ADDENDUM NO. 2

TO: PLANS AND SPECIFICATIONS FOR STATE OF MISSOURI

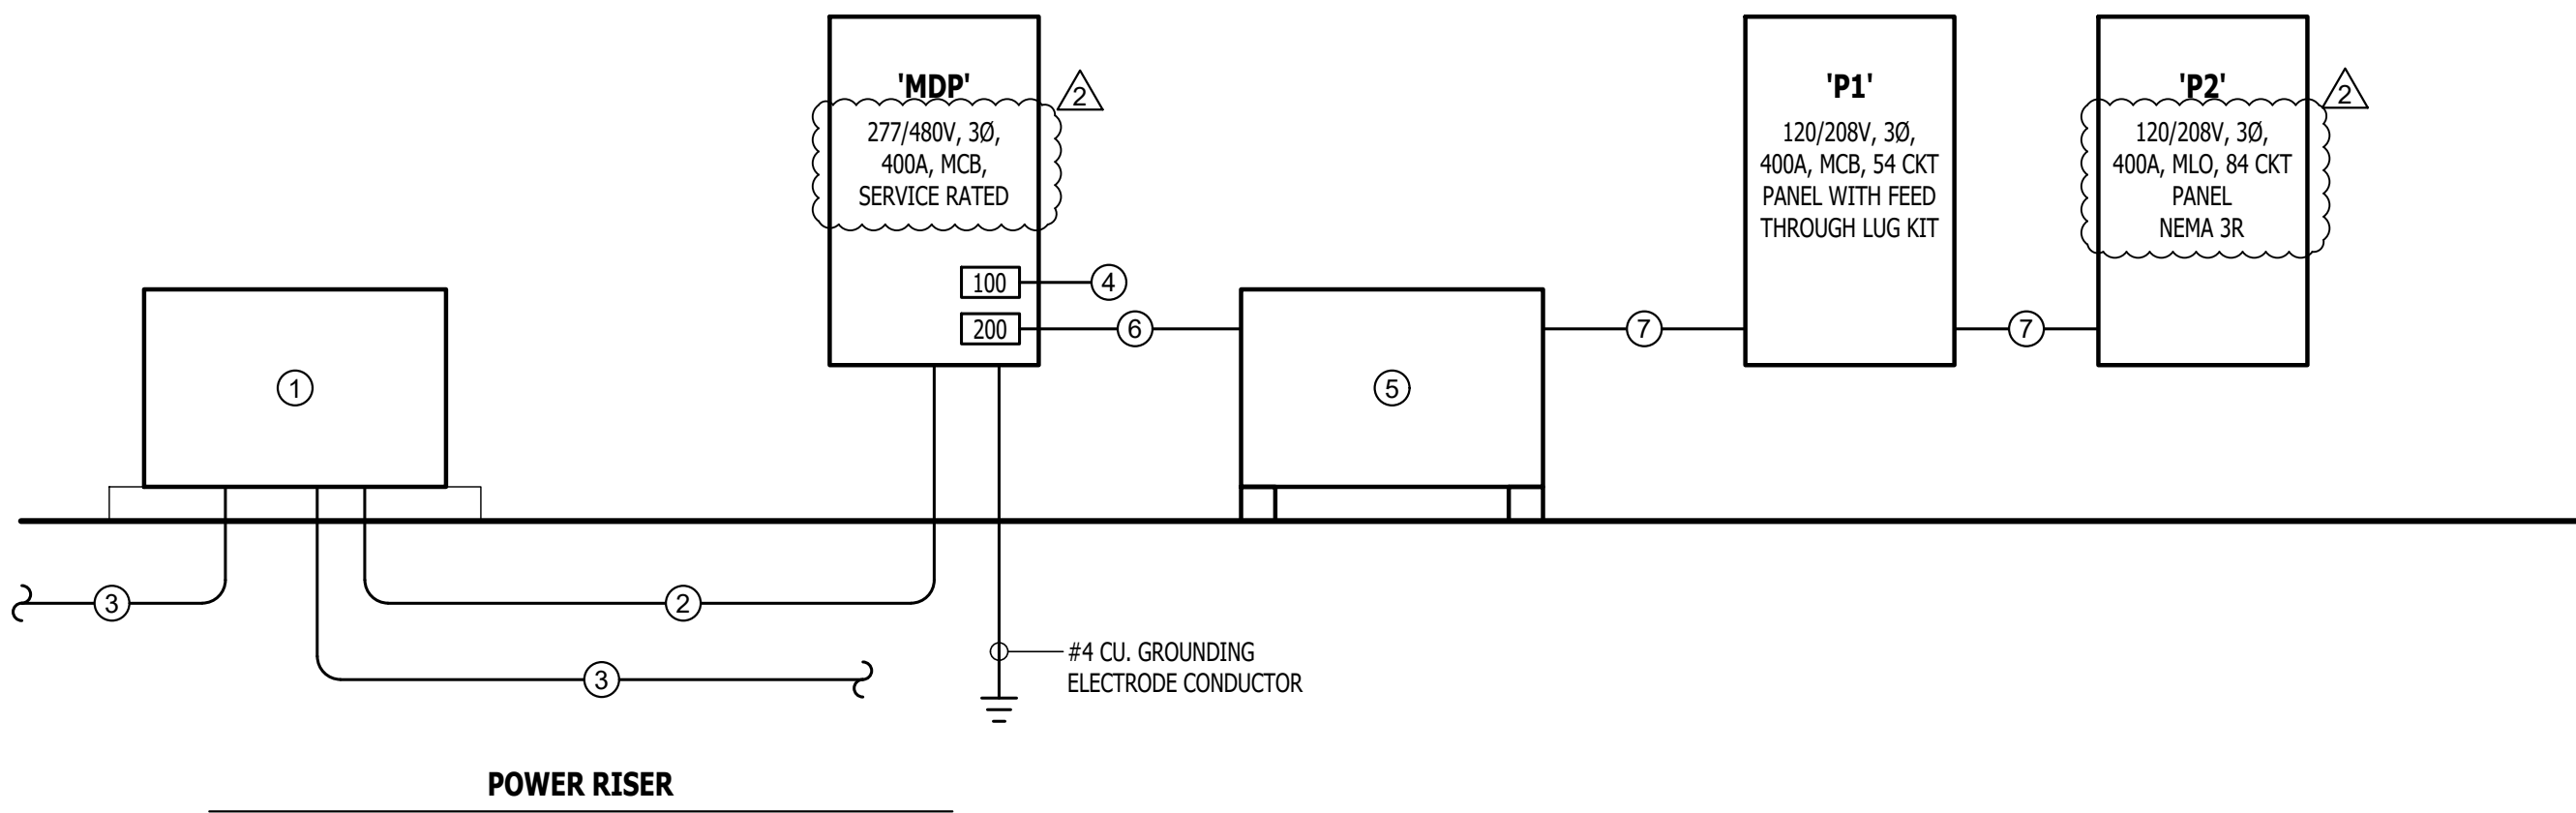
- COORDINATE ALL CHANGES AND NEW SERVICE CONNECTIONS WITH MISSOURI STATE FAIR STAFF FOR STAGING AND OUTAGE TIMES.
- SEE AERIAL PHOTO MARKUP FOR FURTHER INFORMATION.
